AGENDA ITEM NO: 7.9

SUBJECT: Arch Developments Ltd.  
Rezoning / 46120 & 46130 First Avenue  
and 9164 Nowell Street DATE: June 28, 2023

DEPARTMENT: Planning Department  
RZ001608, DVP01353 & DP001583 PREPARED BY: Stella Xiao / sw

**STAFF REPORT ON REZONING APPLICATION RZ001608, DEVELOPMENT VARIANCE PERMIT APPLICATION  
DVP01353 & DEVELOPMENT PERMIT APPLICATION DP001583**

### Condition 1 and 8

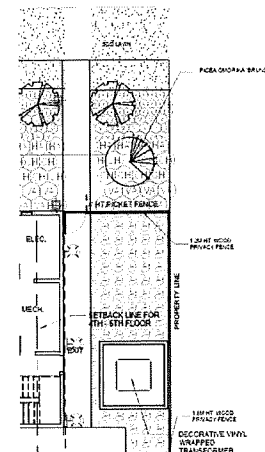
1. *that all utility equipment, including mailboxes and mechanical equipment, be wrapped or screened from public view through a combination of landscaping, vinyl adhesives, and/or fencing;*

7. *that all tree species utilized along the street frontages are selected to accommodate the overhead power lines;*
8. *that additional planting be provided along the northeast property line to increase visual interest and screening of the utility box;*

In response to the first and eighth conditions, an additional conifer tree was added between the PMT and First Avenue along with vinyl wrapping to provide further screening in addition to the previously provided tree and 1.2m fencing. A condition has been added to the draft Development Permit (DP) to ensure compliance.

**Conditions 5 & 6**

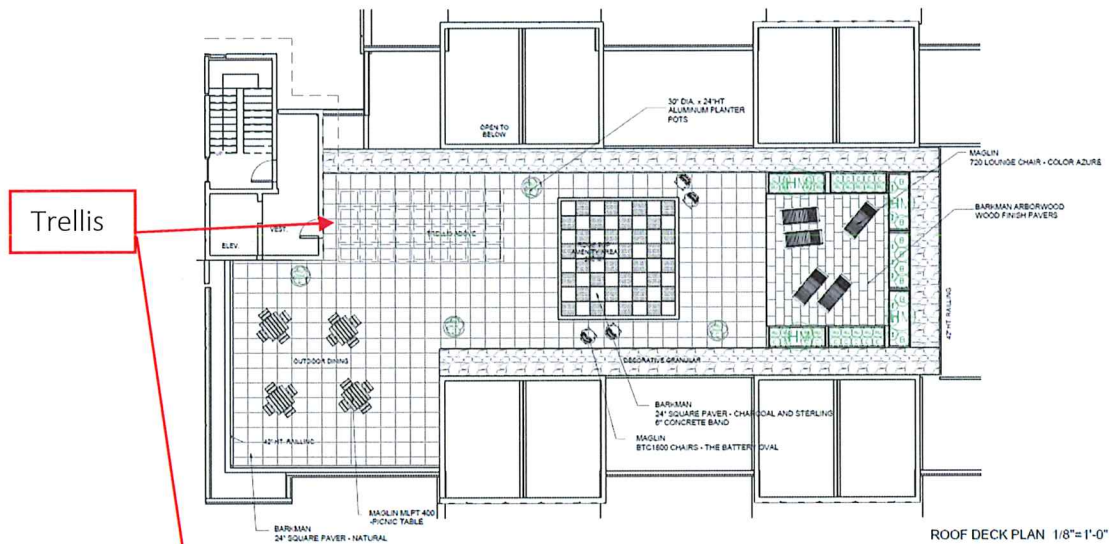
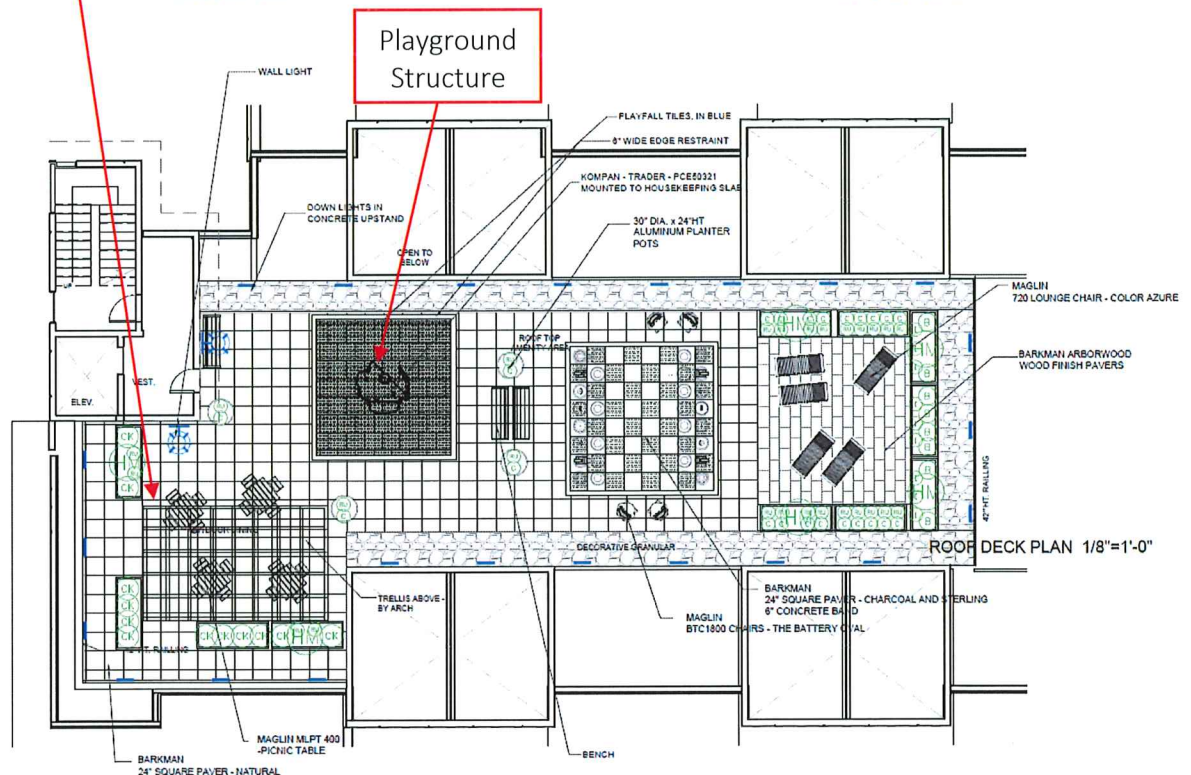
5. *that programming to accommodate younger age groups be incorporated into the outdoor common amenity area;*
6. *that additional plantings or a structure be provided in the rooftop common amenity area to provide shade on the south and west sides of the space;*

In response to DRAC's recommended condition for children's programming, a play structure was added to the rooftop common amenity area on a play fall tile surface. The previously provided trellis was also relocated to the southwest corner of the amenity area with additional plantings framing the area to address DRAC's fifth condition. Both conditions have been included within the draft DP to ensure inclusion at time of Building Permit application.

**Condition 9**

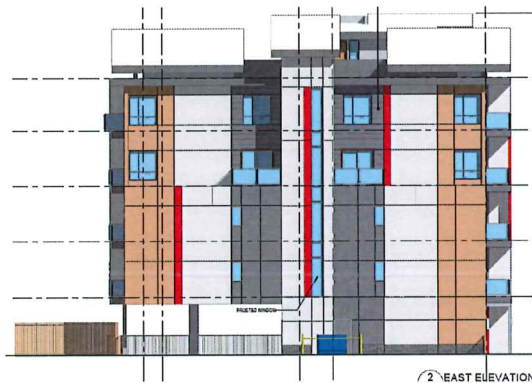
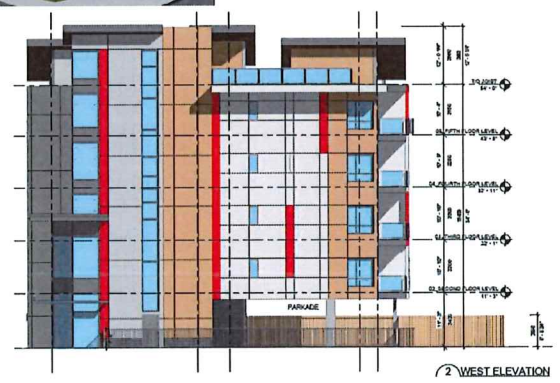
9. *that additional and varied colours or building materials be incorporated onto both the east and west building elevations to provide further visual interest and reduce massing; and,*

The east and west building elevations were revised to provide additional and varied colours and building materials by removing all black accent stucco to brighten the two building faces and adding red metal panel accents throughout to add visual interest.
